TOWN OF JONESBOROUGH
Town Hall Board Room
123 Boone Street
Jonesborough, TN 37659

The Jonesborough Tree and Townscape Board will meet at 10:00 a.m., Tuesday, March 24th, 2026, in the Board Room at Town Hall, 123 Boone Street, Jonesborough, TN, to consider the following agenda:

SUBJECT: Trailblazer Coffee

LANDSCAPE PLAN
 L-11

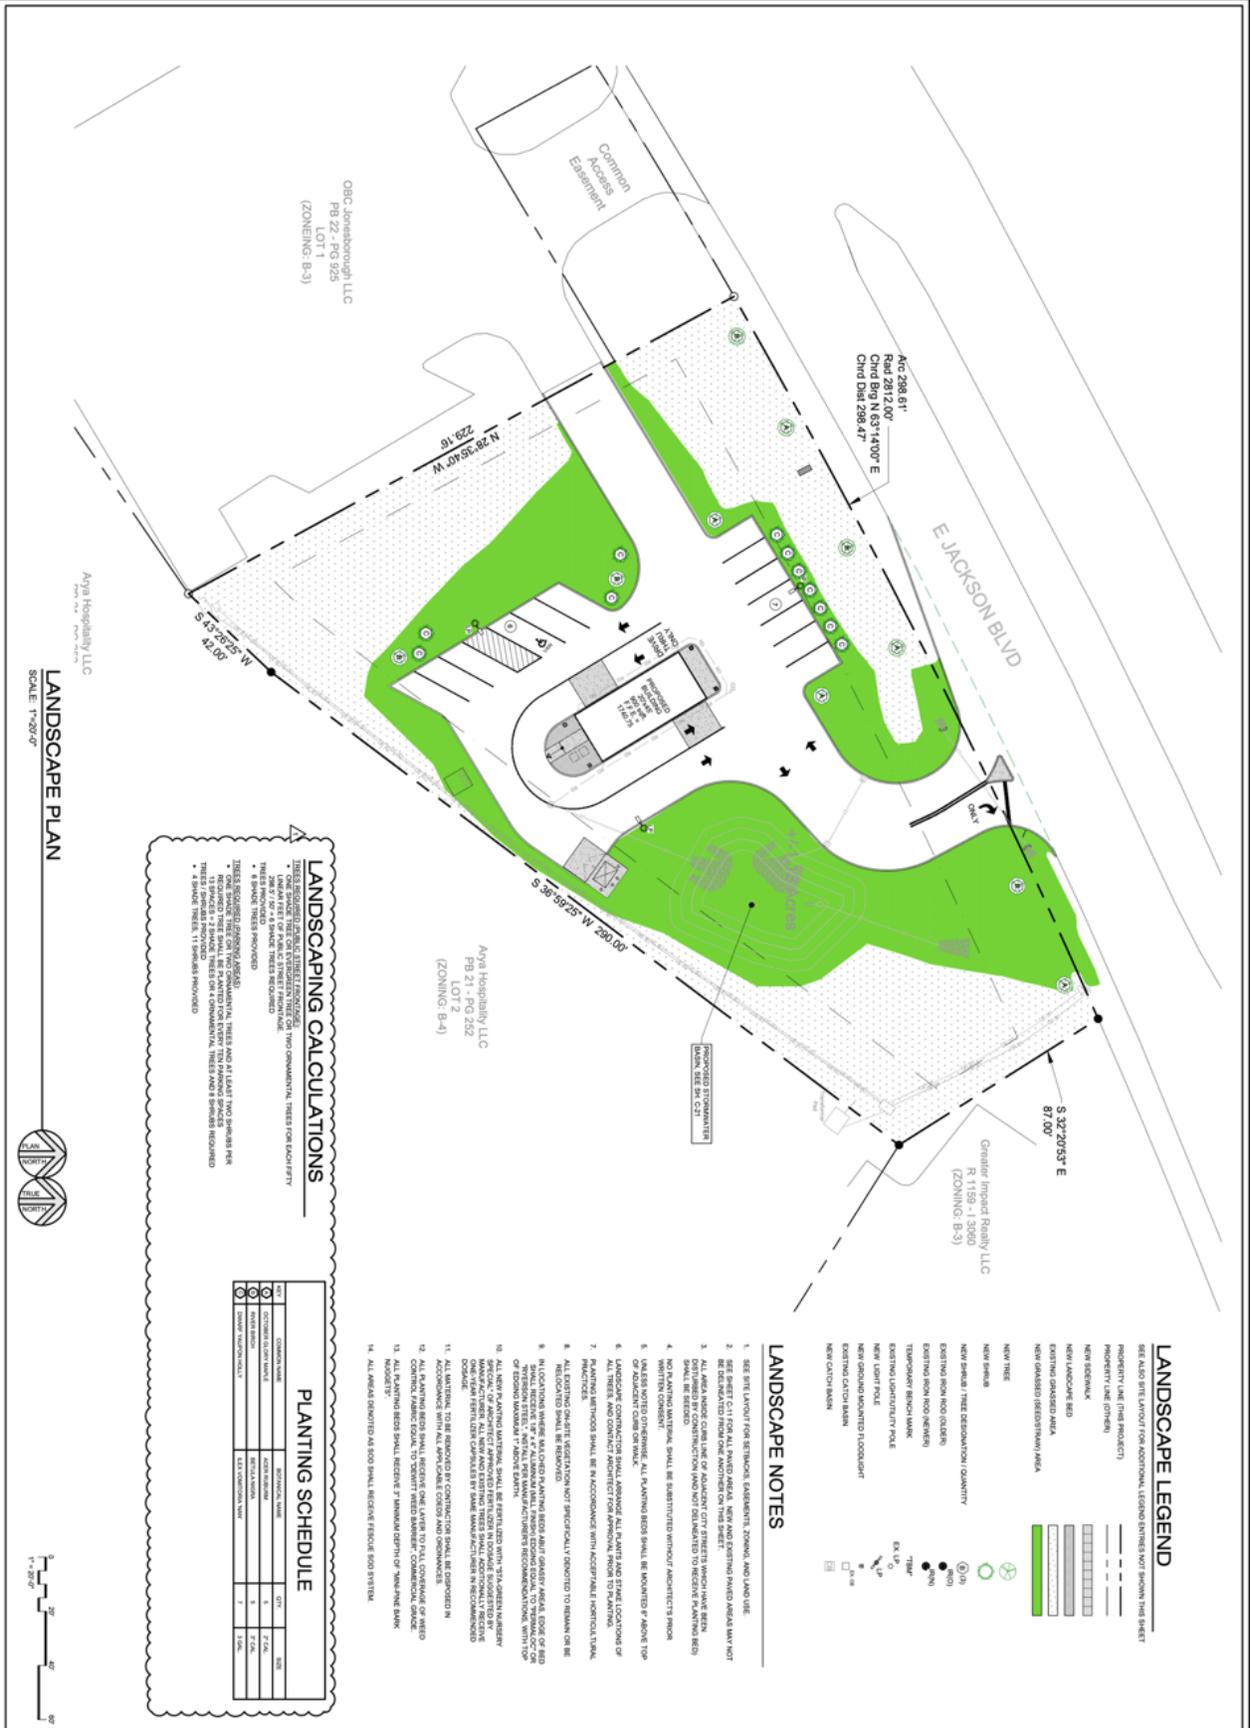
The east and west properties adjoining 304 East Jackson Blvd. are zoned B-3 Arterial Business. The south property is zoned B-4 Intermediate Business. Therefore, no buffer is required as stated in section 11-611, Buffering, of the Landscape Requirements.

The north side of the property facing East Jackson Blvd. will require road frontage landscaping. The linear footage measures 295'. Frontage requirements include one (1) tree for every 50'. $1 \text{ tree}/50' \times 295' = 5.9 \sim 6 \text{ trees}$.

Three (3) October Glory Maple and three (3) River Birch shade trees have been provided. This satisfies the road frontage requirements.

13 parking spaces including 1 ADA space have been provided. 1 tree is required per every 10 parking spaces with at least 2 shrubs per tree. $1 \text{ tree}/10 \text{ spaces} \times 13 \text{ spaces} = 1.3 \sim 1$ tree with 2 shrubs.

Two (2) October Glory Maple and two (2) River Birch along with eleven (11) Yaupon Holly shrubs have been provided. This satisfies and exceeds the landscape requirements.

The Trailblazer Coffee Landscape Plan meets the minimum standards as per the Town's landscape requirements.

Approve the landscape plan as submitted.
